## EAST AYRSHIRE COUNCIL

### PROPOSED INSTALLATION OF SPEED TABLES - VARIOUS ROADS B705, CATRINE

#### Report by the Depute Chief Executive/Executive Director of Neighbourhood Services

Title: East Ayrshire Council  
 Road Safety Improvements  
 B705 Catrine  
 Road Humps Notice

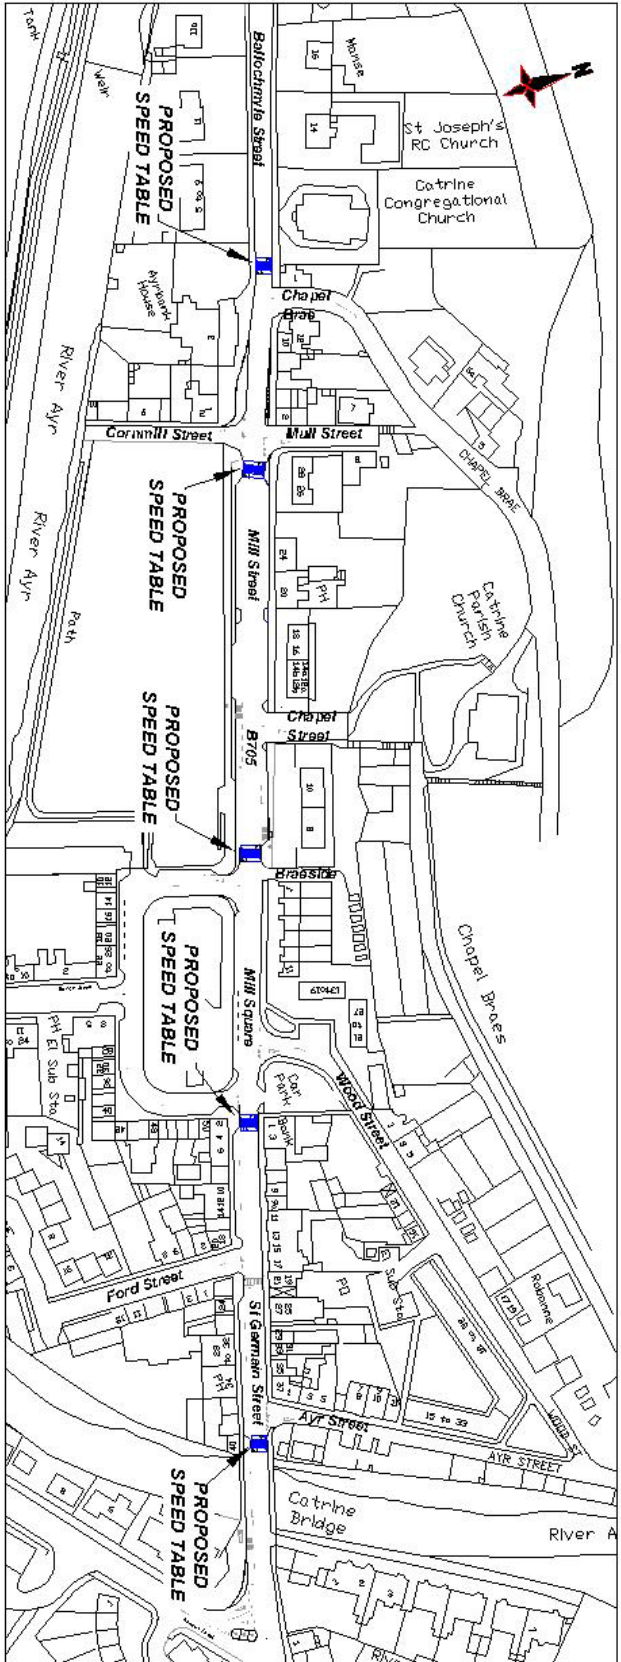
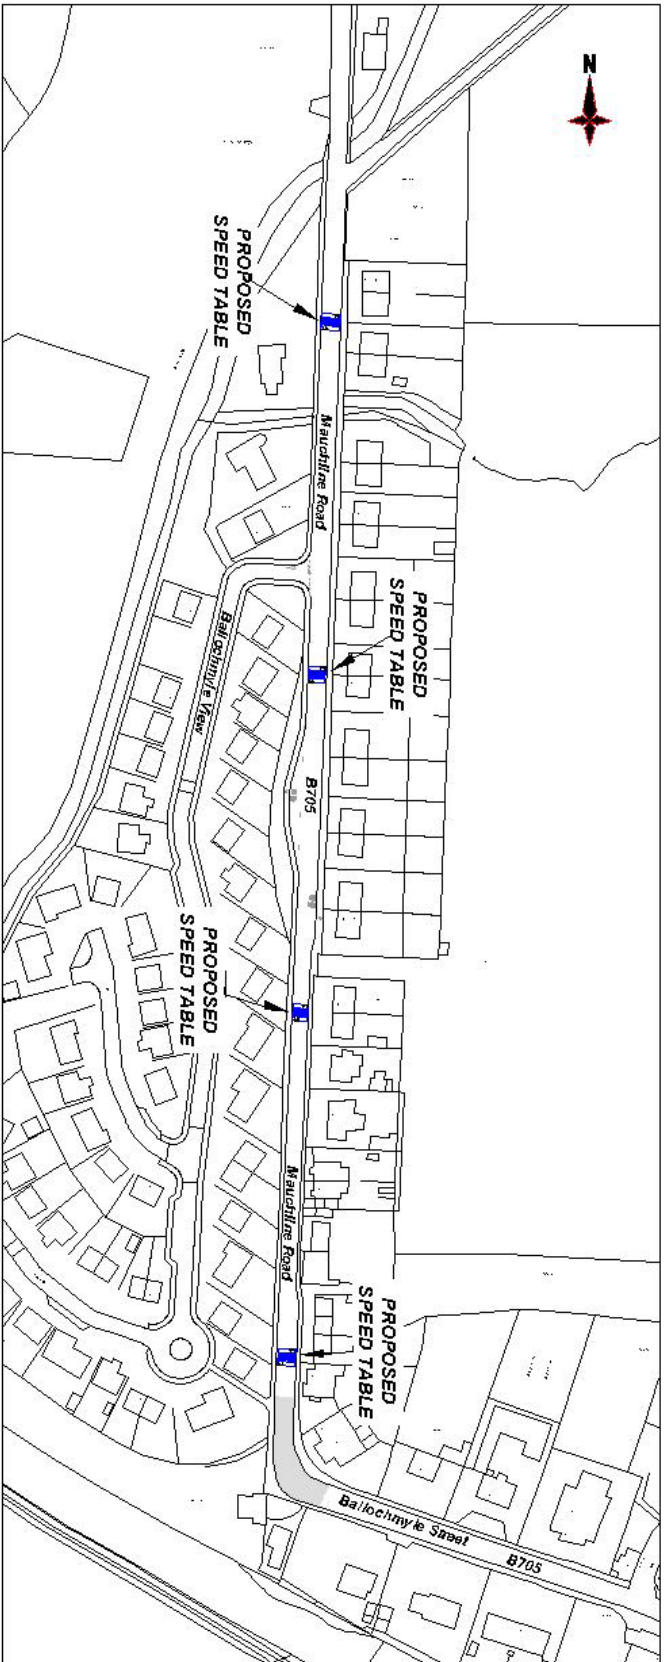
- (a) Does not object to having the traffic controlled at a safe speed. However location of speed tables are “hit or miss” and requests that other forms of traffic calming are used.
- (b) From the location plan it appears that one of the proposed speed tables is located directly outside the bedroom window of his property and he does not want it to be positioned there.
- (c) Increased noise pollution (when vehicles are slowing down and then speeding up once over the speed table)
- (d) Increased vibration caused by large trucks manoeuvring over speed table could damage the 203 year old property.

- (a) The number of speed tables proposed is in excess of the number necessary to reduce speed in the area.
- (b) Stated that only three speed table would be required initially with one at either end of the village and one in the area of the Old Mill.
- (c) Objector 2 has expressed the view that using three speed tables initially would reduce costs and allow for a period of appraisal before increasing the number above three.

- (a) States that the proposed speed table on Mauchline Road should be moved closer to the play park at the end of the village with another installed outside the village boundary.
- (b) Two other proposed speed tables within the village are not needed: one approaching the sharp bend on Mauchline Road and the other on Mill Street.
- (c) Objector 3 asks why speed tables have not been continued through to the opposite end of the village.

- (a) In their experience the majority of motorists do not drive excessively on Ballochmyle Street. The small minority that do are likely to see the speed tables as entertainment rather than a restriction on speed.
- (b) Concerned about speed tables increasing noise, air pollution and delaying emergency services.
- (c) As Ballochmyle Street is used by large number of heavy vehicles travelling to Glen Catrine bonded warehouse and a major bus route, the impact of the speed tables would be a serious detriment to residents in the area.
- (d) States that many Councils in England are removing speed humps due to concerns regarding noise, air pollution and complaints from emergency services.
- (e) Requests that consideration is given to introduction of alternative measures to slow down traffic through Catrine. Proposed introduction of 20mph zones and flashing lights.

- (a) The traffic calming scheme was proposed in response to local road safety concerns. The B705 within Catrine is a long straight road with a significant potential for higher speeds.

- (a) & (b) Speed tables are an effective way to deter speeding, improve the pedestrian environment and enhance community safety, especially for vulnerable road users such as children, the elderly, pedestrians and cyclists. The speed tables are located at regular intervals to ensure that drivers maintain a uniform reduced speed. All speed tables have been carefully positioned to minimise interference with private accesses.

However, because of the close proximity of this house and particularly the bedrooms to the speed table, it is proposed to remove the traffic calming feature on Ballochmyle Street near Chapel Brae from the scheme and provide vehicle activated speed warning signs for traffic travelling in both directions. If this change is agreed, the situation will be monitored and if speeds are not reduced, consideration will be given to providing a further speed table, at a location nearby, as part of a future programme.

- (c) & (d) Speed tables are a nationally recognised road safety feature. The maximum permitted height is 100mm; however the ones in Catrine will be limited to 75mm. The approach ramps will also be lengthened to minimise discomfort whilst deterring speeding. Regularly placed traffic calming measures, resulting in reduced, steady speeds, will contribute to a reduction in traffic related noise, vibration and atmospheric pollution.

- (a) The proposed road humps have been designed in accordance with the current national guidelines and specifications and are a standard road safety feature. The speed tables have also been positioned where they will be most effective in reducing vehicle speeds; enhancing road safety; and minimising interference with private accesses and road drainage.
- (b) & (c) The spacing of the speed tables has been designed to ensure that drivers maintain a steady, reduced speed along the length of the road. Experience has shown that drivers often speed up between traffic calming features if they are too widely spaced. Reducing the number of speed tables to three would lessen the overall effectiveness of the scheme and speeds would not be reduced through the town.

- (a) To move the speed tables closer to the play park will require an extension of the existing street lighting system. There are currently no proposals to extend the existing street lighting, however the request will be kept on file for future consideration.

- (b) The speed tables have been positioned where they will be most effective in reducing vehicle speeds, enhancing road safety and minimising interference with private accesses and road drainage. The speed table positioned on the approach to the bend at the end of Mauchline Road has been added as an additional measure to encourage vehicles to slow down for the bend.
- (c) The existing road surface at the opposite end of the village requires resurfacing works to be carried out before traffic calming could be introduced. Once this work is completed, consideration can be given to additional traffic calming at this location as part of a future programme.

- (a) The traffic calming scheme was proposed in response to local road safety concerns. The B705 within Catrine is a long straight road with a significant potential for higher speeds.
- (b) & (d) The speed tables are located at regular intervals to ensure that drivers maintain a uniform reduced speed along the length of the road. This will contribute to a reduction in traffic related noise, vibration and atmospheric pollution.
- (c) All emergency services and relevant bus companies have been consulted as part of the statutory consultation process with no objections received. The proposed traffic calming measures will deter lorries from speeding.
- (e) Road humps are an effective way to deter speeding, improve the pedestrian environment and enhance community safety, especially for vulnerable road users such as children, the elderly, pedestrians and

cyclists. Part-time 20mph limits, with flashing lights to show when the limit is in force, are generally only introduced in the vicinity of schools.
